Re: Revised Percolation Testing and On-Site Wastewater Treatment System (OWTS) Design
Proposed Rancho Yard Building
San Bernardino County Public Works Department:
12158 Baseline Road, Rancho Cucamonga, California
Assessor Parcel No. 1089-031-39

OWTS REVIEW - OFFICIAL INSPECTION REPORT

OWTS REVIEW - Commercial Dvlpmnt Perc Test Review

SEPTIC TANK, DISTRIBUTION BOX, SEEPAGE PIT - TYPICAL PROFILE

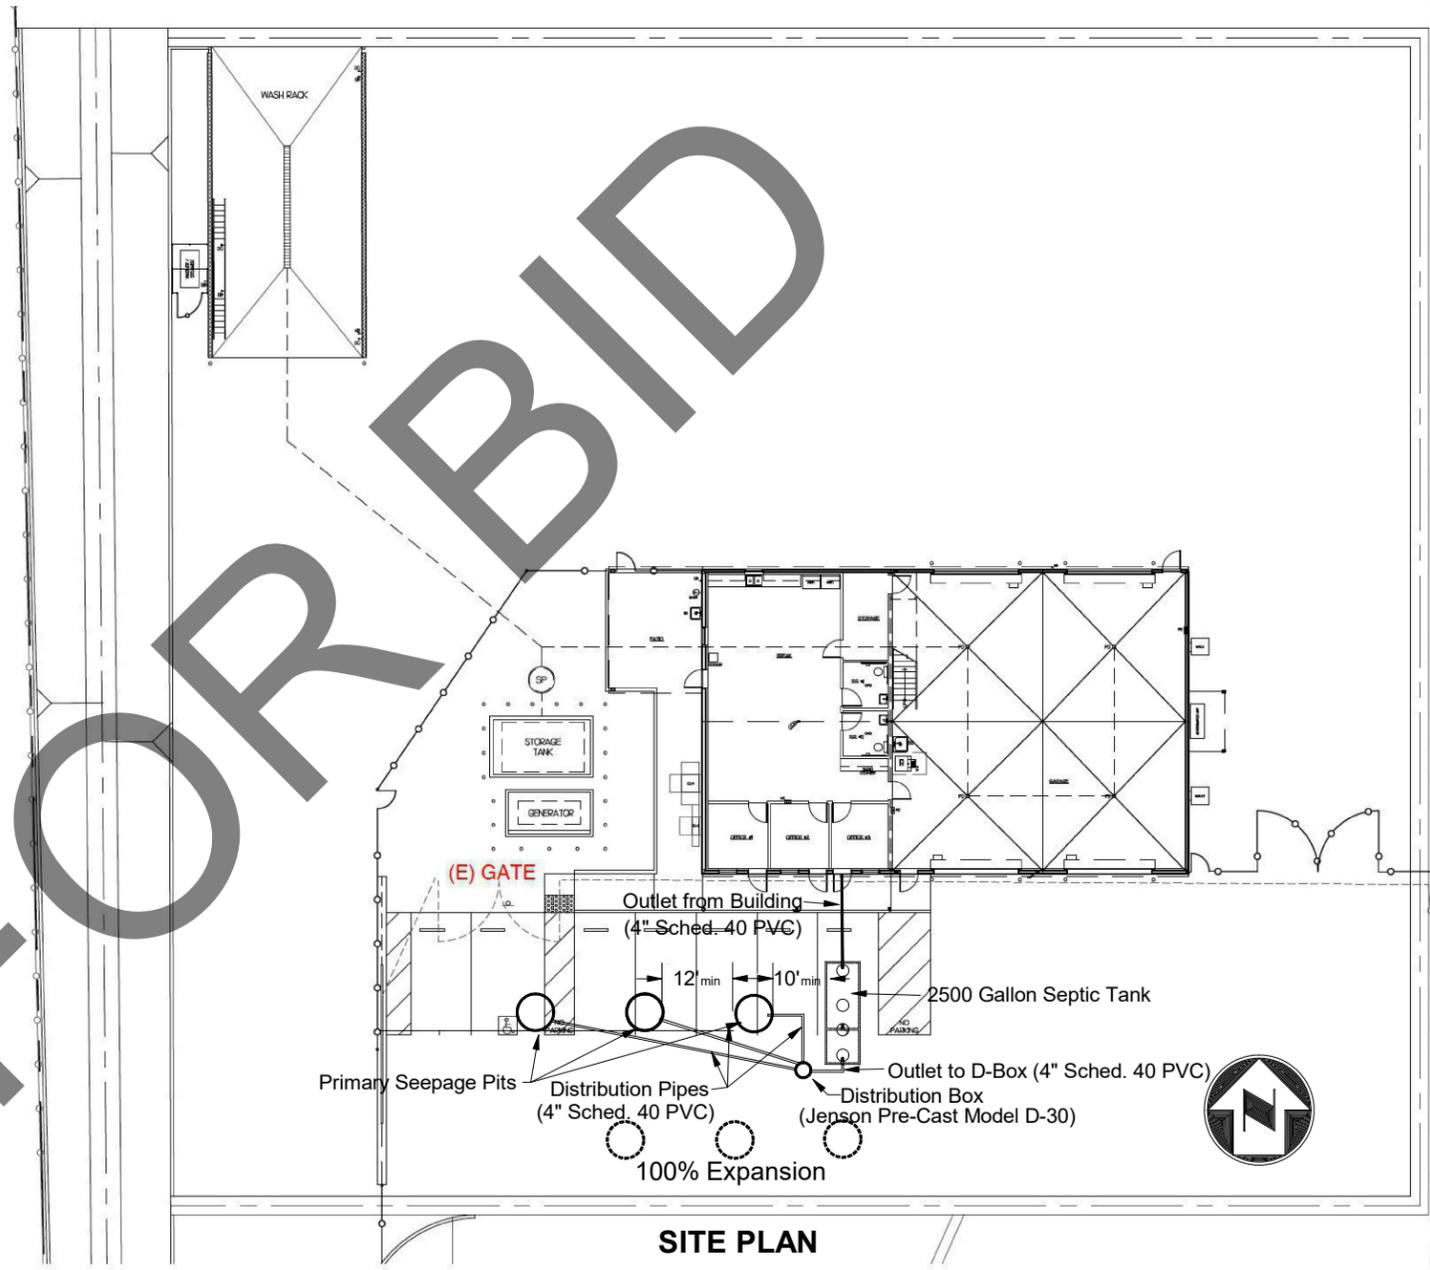
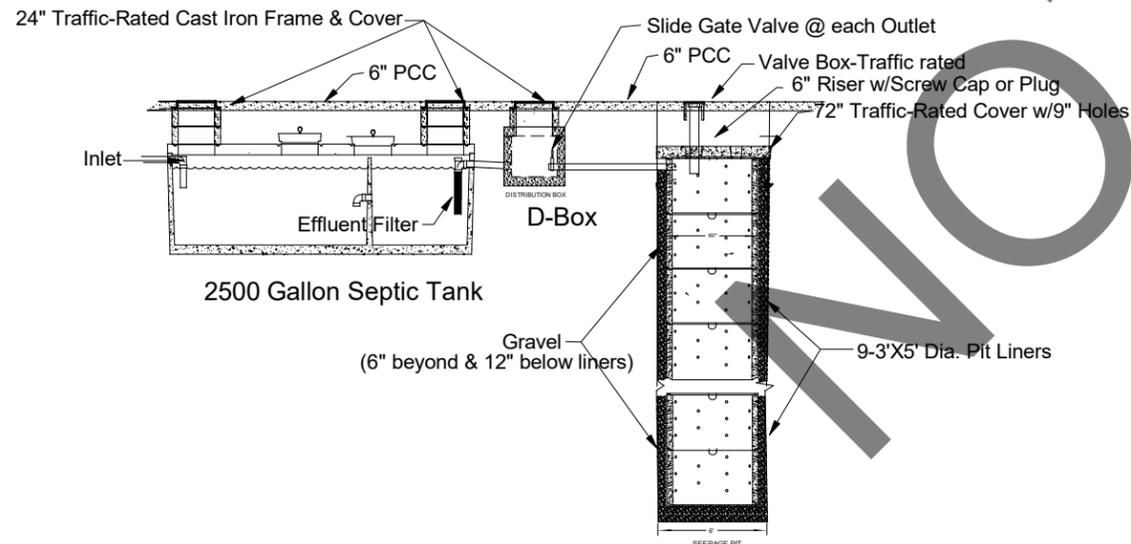
Inspector Comments: Provide occupancy information/calculations in estimated wastewater flow for the project according to the California Plumbing Code Table H 201.1(2)

Description: The septic tank size shall be based on the number of fixture units or the estimated daily flow based on the type of business, whichever is greater. Refer to 2013 CPC Table H 2.1 and H 2.1(1). Calculations for the fixture unit count and estimated daily flow shall be provided with the plot plan.

FIXTURE UNITS SEPTIC TANK CAPACITY (per Table H 201.1(1))
 Fixture Units (See Report): 28
 Minimum Septic Tank Capacity per Table H 201.1(1) = 1500 gallons
 FLOW RATE DETERMINATION (Table H 201.1(2))
 No. of Employees; 16
 Gals/Employee: 25
 Daily Flow = 25 gals/person X 16 people = 400 gals/day
 Minimum Septic Tank Capacity per Table H 201.1(2) = 400 gals. X 1.5 = 600 gallons
 DESIGN SEPTIC TANK CAPACITY: 2500 Gallons
 PERCOLATION RATE: 1.7 Gallons/Square Foot/Day
 NUMBER OF SEEPAGE PITS: 3
 SEEPAGE PIT DIAMETER: 6 Feet
 SEEPAGE PIT DEPTH: 27 Feet Below Inlet
